**OFF-SITE IMPROVEMENTS FOR THE LANDFILL PROJECT
3rd Street from east of Central Avenue to west of Palm Avenue**

Inland Valley Development Agency

ADDENDUM NO. 1

C-301

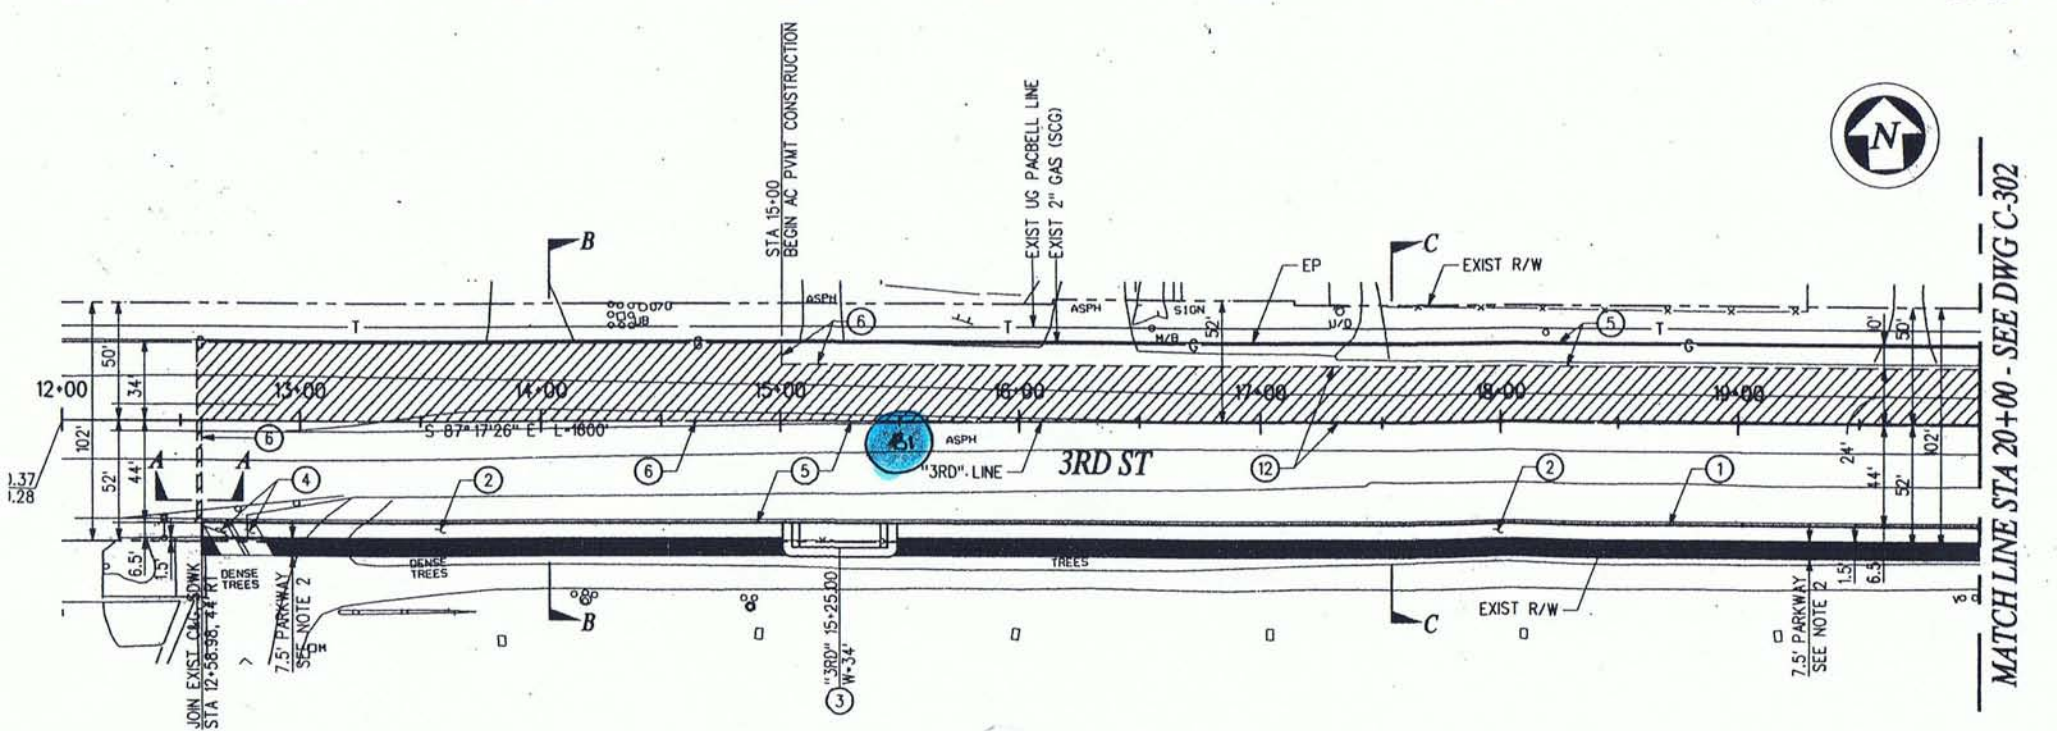
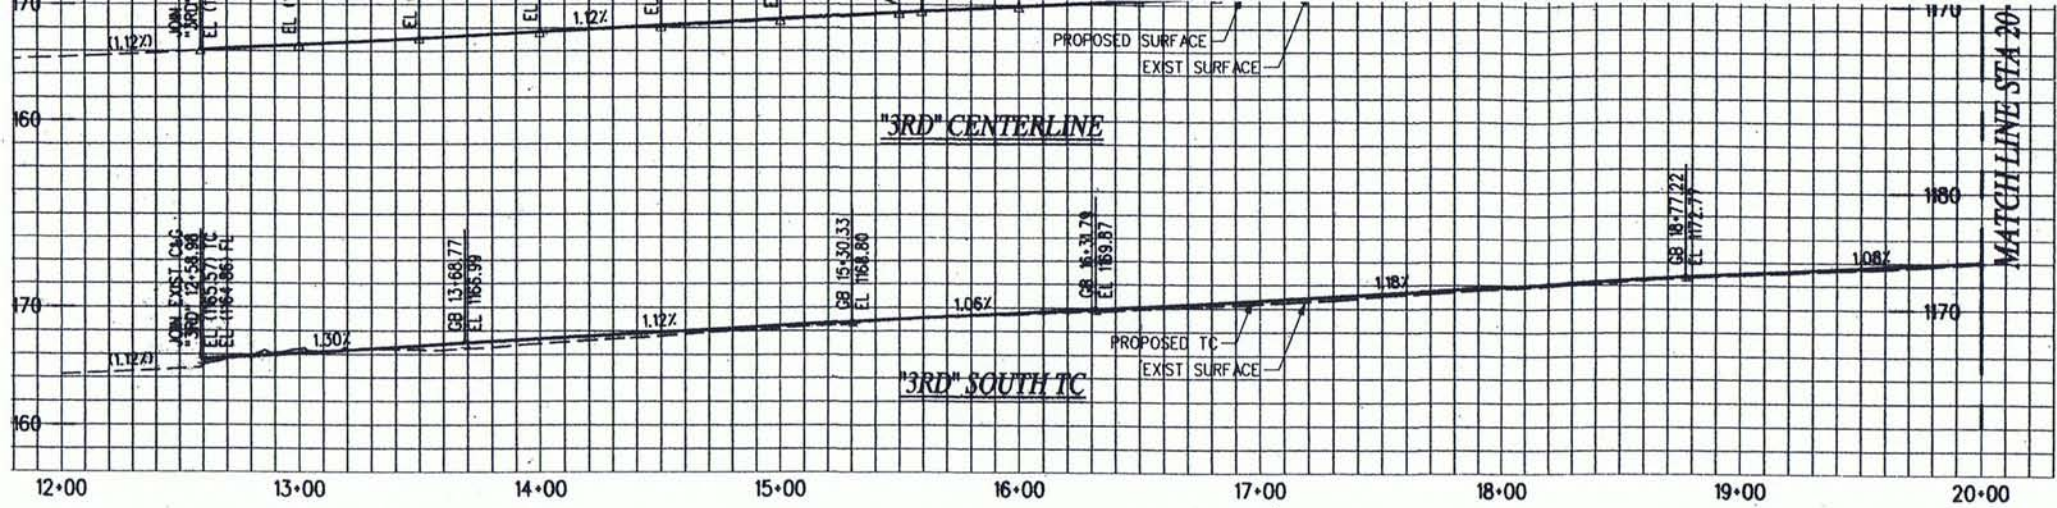
A geotechnical report was not done for this Project. However, two borings were drilled within the site (see attached drawings). The following is a summary of the different layers encountered for borings B-1 and B-2 along 3rd Street:

Boring B-1

Asphalt Concrete=	9 inches
Base=	Not encountered
Subgrade Soils=	Medium dense, moist, brown Silty Sand (SM)

C-302

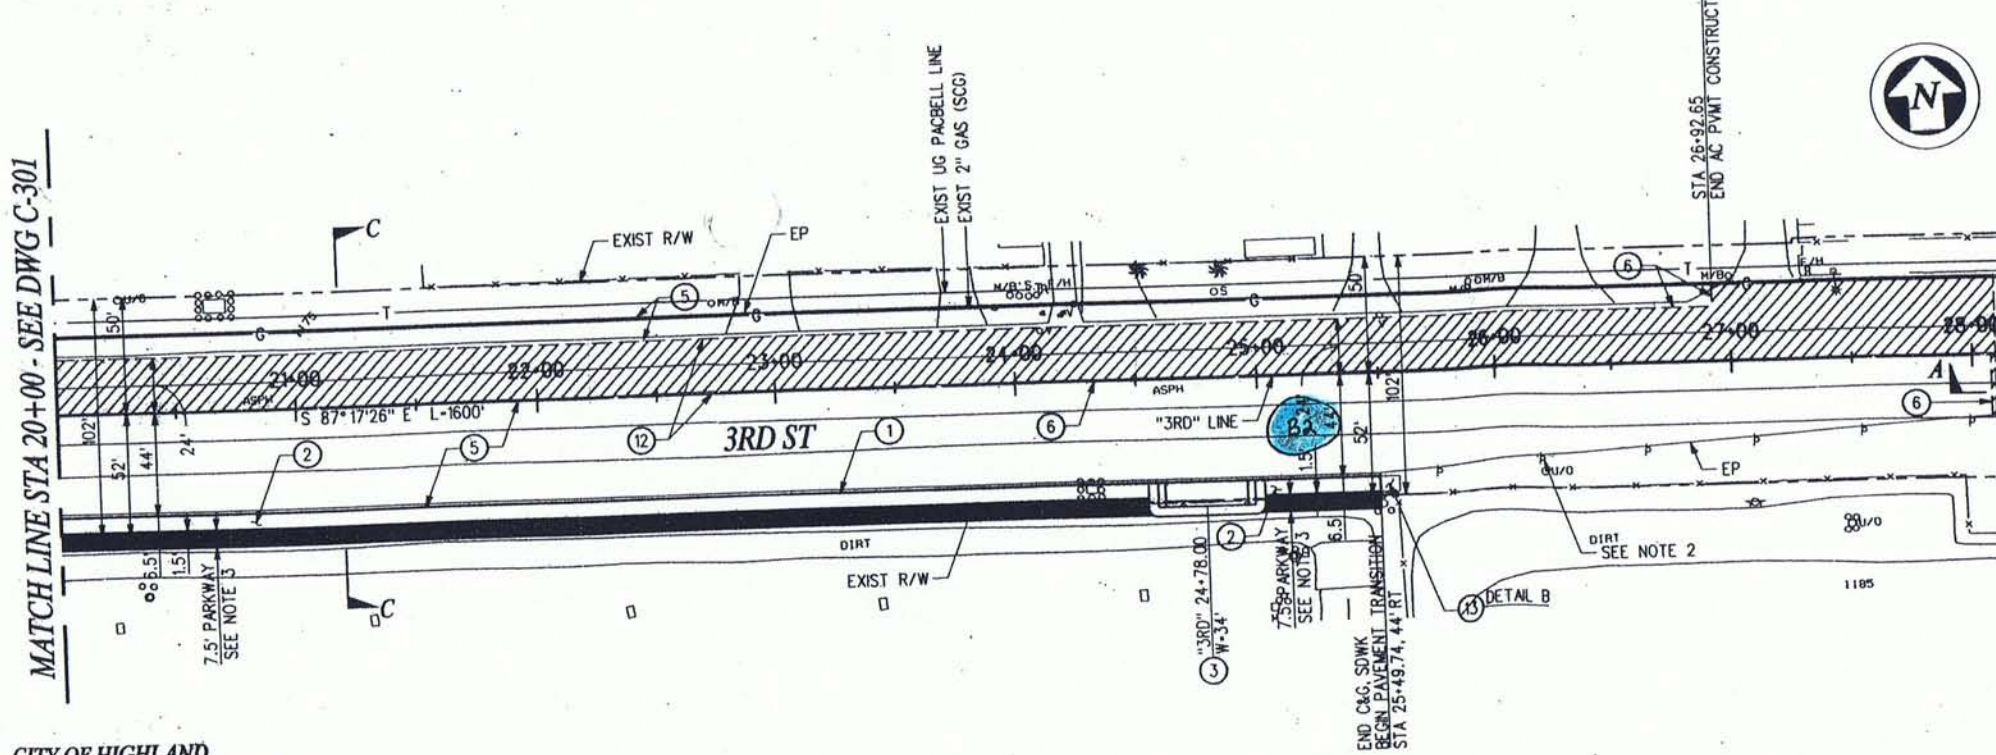
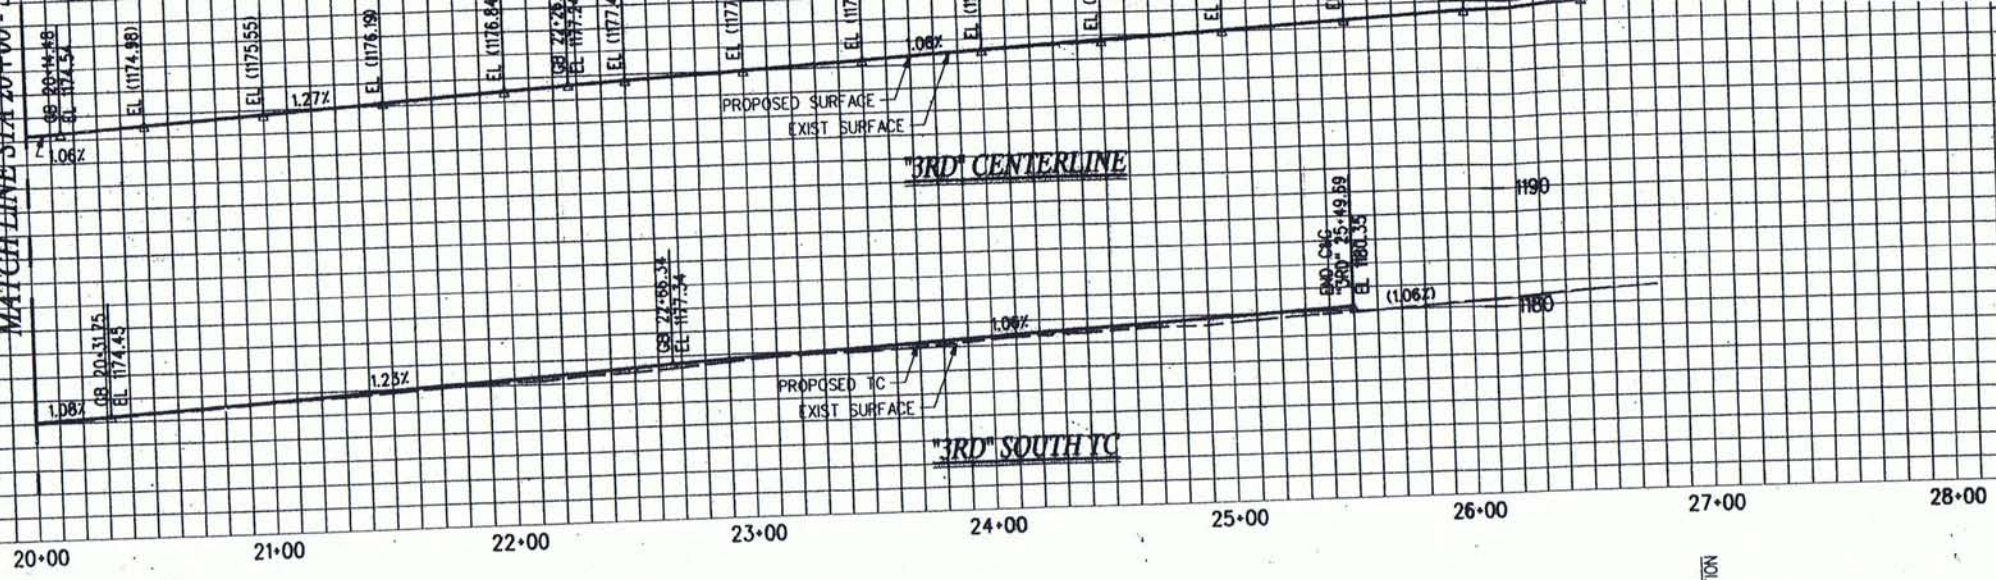
Boring B-2

Asphalt Concrete=	5 inches
Base=	None
Subgrade Soils=	Medium dense, moist, brown Silty Sand (SM)
